## NOTICE OF DECISION

**Case File:** T2-2014-3448  
**Permit:** National Scenic Area Site Review & Major Variance  
**Location:** 36911 NE Clara Smith Road  
Tax Lot 1300, Section 26CA,  
Township 1 North, Range 4 East, W.M.  
Tax Account R944260540  
**Applicant:** Tim & Jill Leitner  
**Owner:** Tim D. Leitner, Sr & Jill A. Leitner  
**Zoning:** Gorge General Residential – 5 (GGR-5)  
**Landscape Setting:** Rural Residential

**Summary:** The applicant is requesting approval of a National Scenic Area Site Review to build a new 3,641 square foot single family dwelling and a 1,596 square foot accessory building in the Gorge General Residential – 5 zone. In addition, a Major Variance request has been submitted to reduce the street side yard requirement from 45 feet to 30 feet adjacent to the unbuilt right-of-way known as Perry-Emerson Road which bisects the property.

**Decision:** Approved with Conditions.

# Exhibit A.55

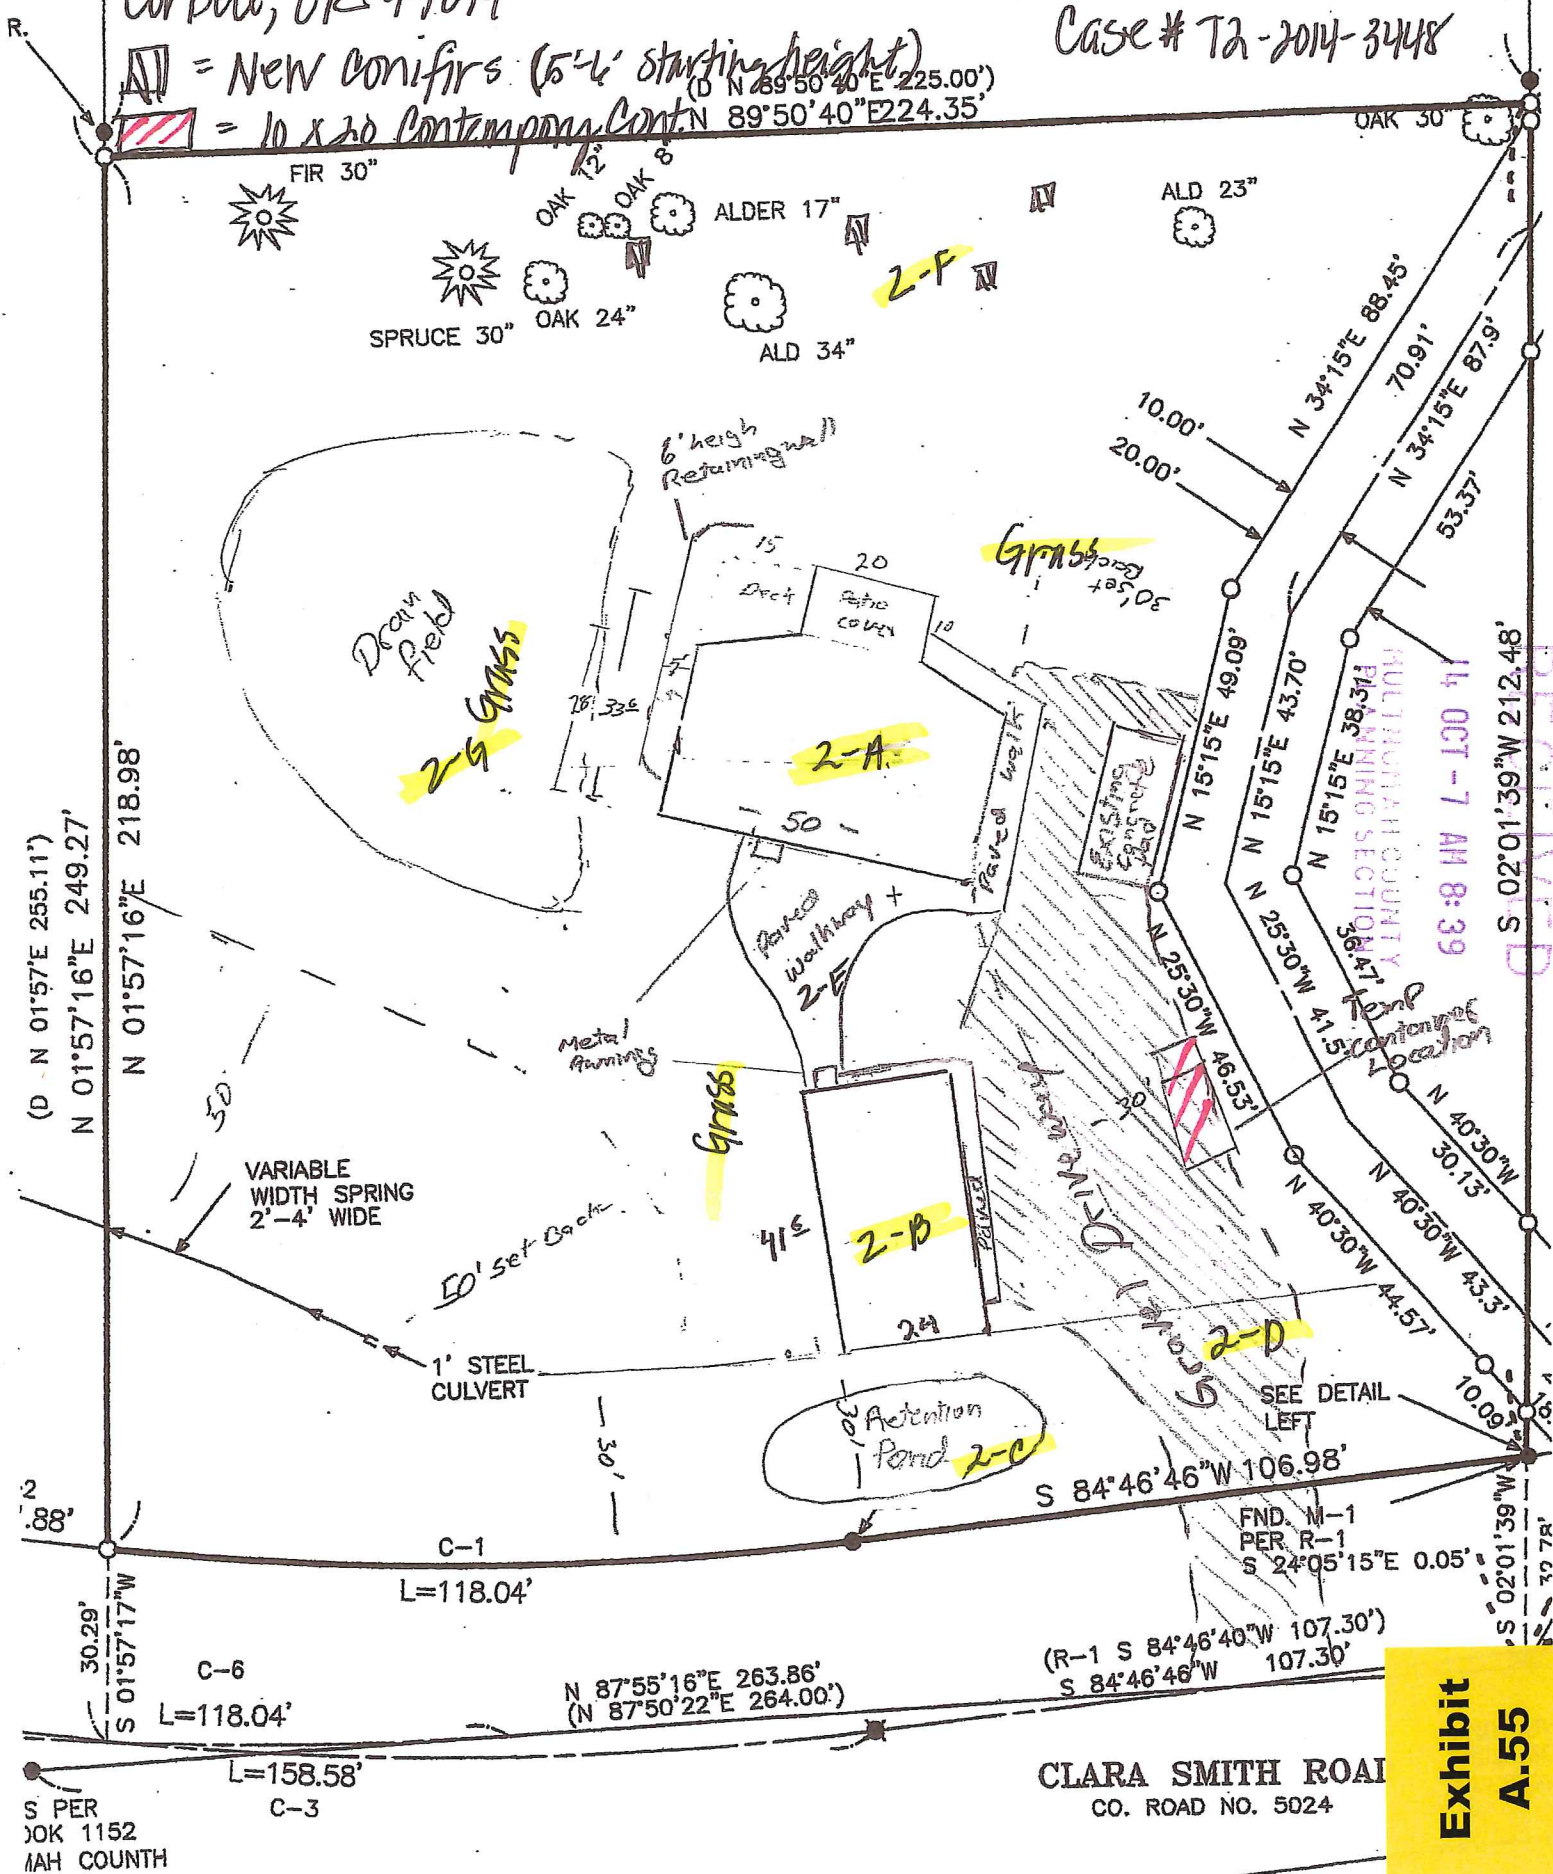
9. Pursuant to MCC 38.7035(A)(4), the present and future property owners shall be responsible for the proper maintenance and survival of all existing trees and required trees shown on the site plan (Exhibit A.55). If a tree becomes diseased, dies or is removed for any reason, it shall be replaced within the next planting season (spring/fall). Replacement trees shall be a minimum of six feet in height and shall be a Douglas fir, Western Red Cedar or Western Hemlock.

10. Prior to land use sign-off for building plan check, the property owners shall revise the site plan to show that the front eaves and the side eaves (east side of the building) of the accessory building are located outside of the yard setbacks of MCC 38.3060(C). In addition, the eaves on the east side of the dwelling shall not be located closer than 29 feet from the western edge of the Perry-Emerson right-of-way.

11. During the winter of 2014-2015, the property owners shall plant the four evergreen conifers as shown on Exhibit A.55. The trees shall be Douglas fir, Western Red Cedar or Western Hemlock or other evergreen tree native to Western Oregon and listed in the Scenic Resources Implementation Handbook. The conifer trees shall be a minimum of 5-6 feet in above ground height when planted. [MCC 38.7035(B)(17)]

1. Prior to land use approval for building plan check, the property owners shall record pages 1 through 3 and Exhibit A.55 with the Multnomah County Recorder's Office. The recordation of this notice and site plan shall be at the property owners' expense. Proof of recording shall be provided to Land Use Planning before authorization for building plan check. [MCC 38.0670]

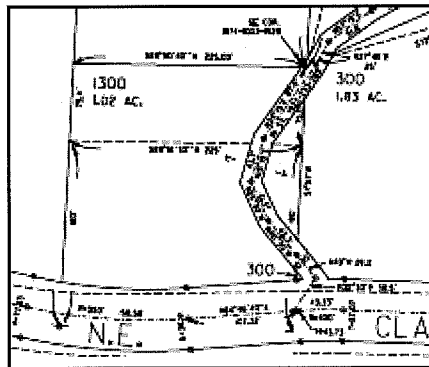
**Staff:** The subject parcel is only 1.02 acres in size and is nonconforming to the minimum lot size of 5 acres. The parcel has a public right-of-way which crosses the property on the eastern portion of the lot from north to south (see graphic below).

In addition, an intermittent stream crosses the property near the southwest corner. The intermittent stream has a 50-foot buffer zone that needs to be maintained as the variance criteria for the buffer cannot be met. The approved septic drainfield location removes additional area available for the proposed development. The site has a number of practical difficulties that require the reduction of the amount of development proposed or a variance be granted. The size of the proposed dwelling and outbuilding is consistent with the general scale of development within the area (see Section 4.06 for more information). *Practical difficulties exist on the subject parcel.*
